Project	<b>IEEE 802.16 Broadband Wireless Access Working Group</b> < <a href="http://ieee802.org/16">http://ieee802.org/16</a> >	
Title	<b>Text remedies for the credit token based co-existence protocol section</b>	
Date Submitted	<b>2006-09-22</b>	
Source(s)	David Grandblaise Motorola Labs Parc Les Algorithmes Commune de Saint Aubin 91193 Gif sur Yvette, France	Voice: +33 (0)1 6935 2582 Fax: +33 (0)1 6935 4801 <a href="mailto:david.grandblaise@motorola.com">mailto: david.grandblaise@motorola.com</a>
Re:	Recirculation of Working Group Review of Working Document 80216h-06_015r1	
Abstract	Follow up the session #44 meeting observations, this contribution provides some editorial text remedies on the credit token co-existence rental protocol section and related sections. The text remedies are proposed for sections 15.4.2.5 and 15.5.2 of the working document [1].	
Purpose	Propose editorial text remedies in the credit token based co-existence protocol section (15.4.2.5) and related section (15.5.2).

# Text remedies for the credit token based co-existence protocol section

Follow up the session #44 meeting observations, this contribution provides some editorial text remedies on the credit

Figure h44—Example of TDD based MAC frame sharing structure between M SYs

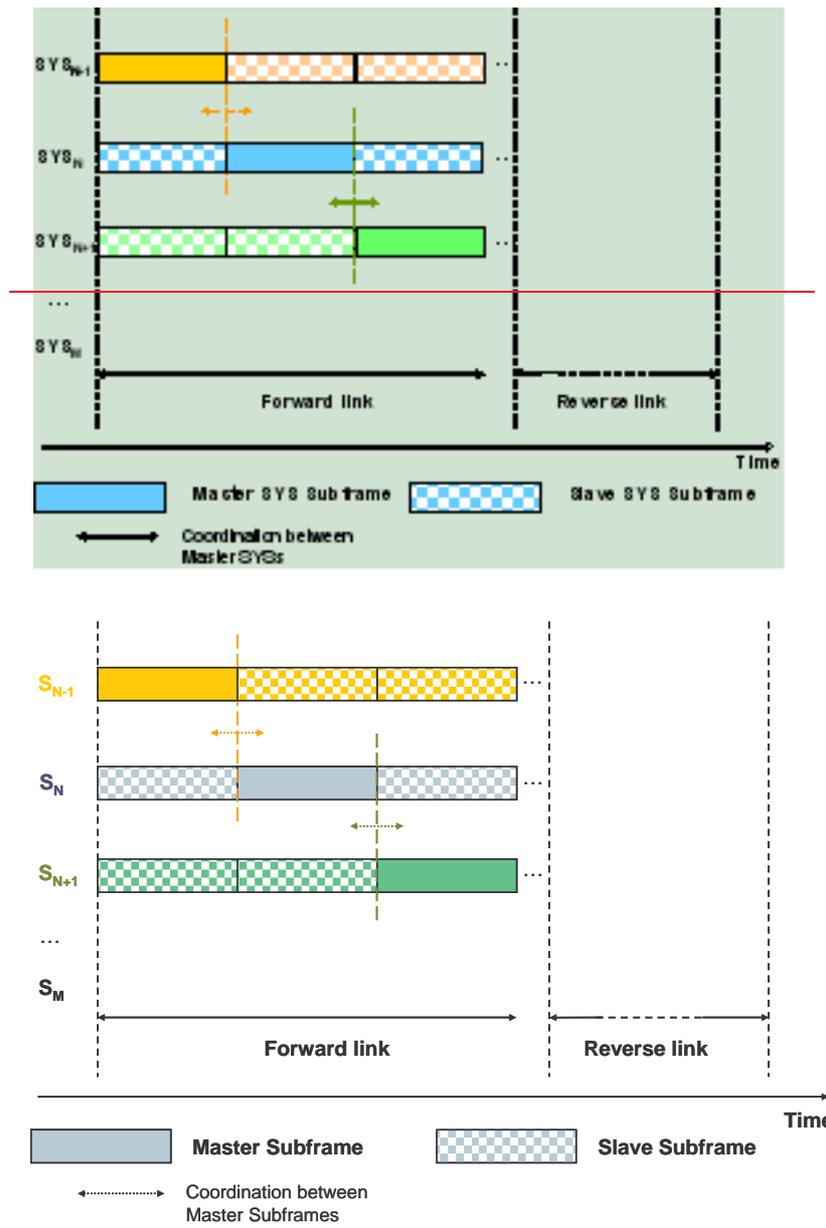
Spectrum sharing between several systems (~~SSYSs~~) can be achieved by the sharing a common MAC frame among different systems (**operated by different operators**) as exemplified by Figure h 44. In such a MAC frame structure, dedicated portions (denoted as “master system sub-frames”) of the frame are periodically and exclusively allocated to a system (denoted as the “master system”) respectively in the forward and reverse link. The terminology used hereafter defines a slave system as a system that may operate during the other master systems sub-frames. With respect to this definition, the slave system sub-frames are the time intervals operating in parallel of the master systems sub-frames.

Figure h45—Dynamic (iterative) credit tokens based scheduling cycle (sequences (1) to (5))

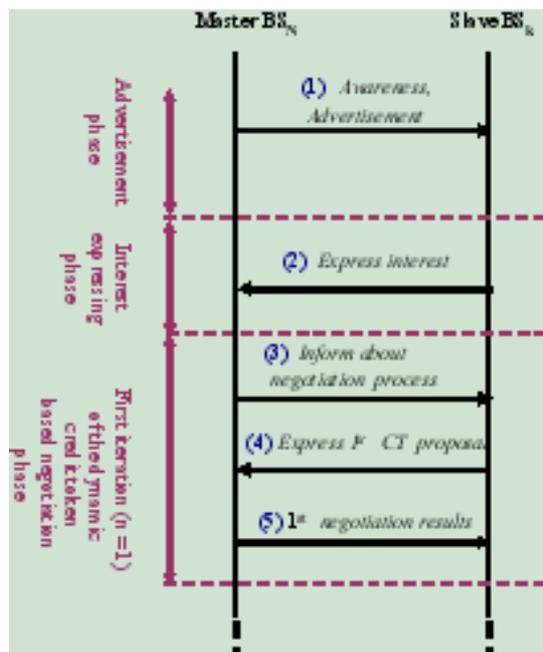
A proposition to update the Figure h45 has been made in contribution IEEE C802.16h-06/080r1. If the contribution IEEE C802.16h-06/080r1 is accepted during session #45, please replace the above Figure h45 by the one proposed in IEEE C802.16h-06/080r1.

Figure h47—Simplified MAC frame structure illustrating master system sub-frame renting principle and associated notations

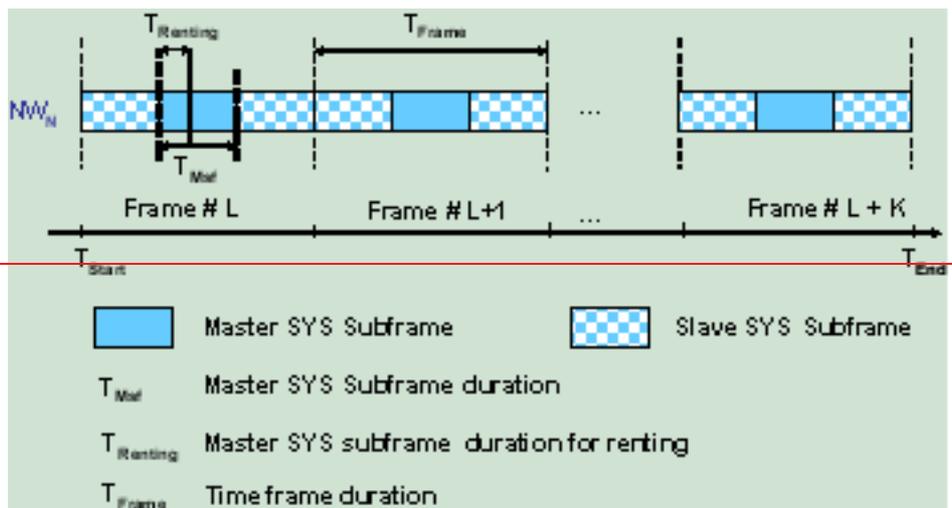
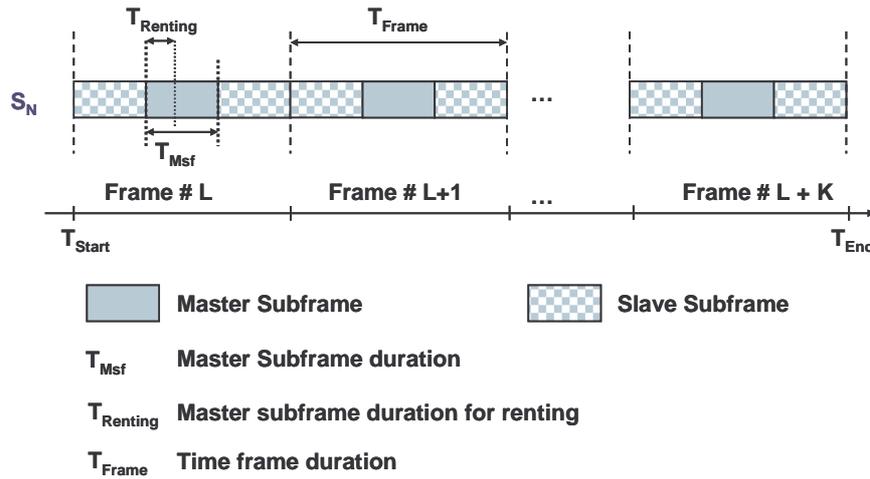
- The master ~~S~~ $S_N$  (offeror) advertises that its periodic assigned master sub-frame is open for renting (Figure h 47) from starting time  $T_{Start}$  to ending time  $T_{End}$  for a fraction ( $T_{Renting}/T_{Msf}$ ) of its master sub-frame duration  $T_{Msf}$ .  $T_{Renting} = T_{End} - T_{Start}$ .
- The master ~~S~~ $S_N$  proposes a minimum number of credit tokens required (MRCTN) for this renting. The MRCTN is expressed as a number of credit tokens per time unit.
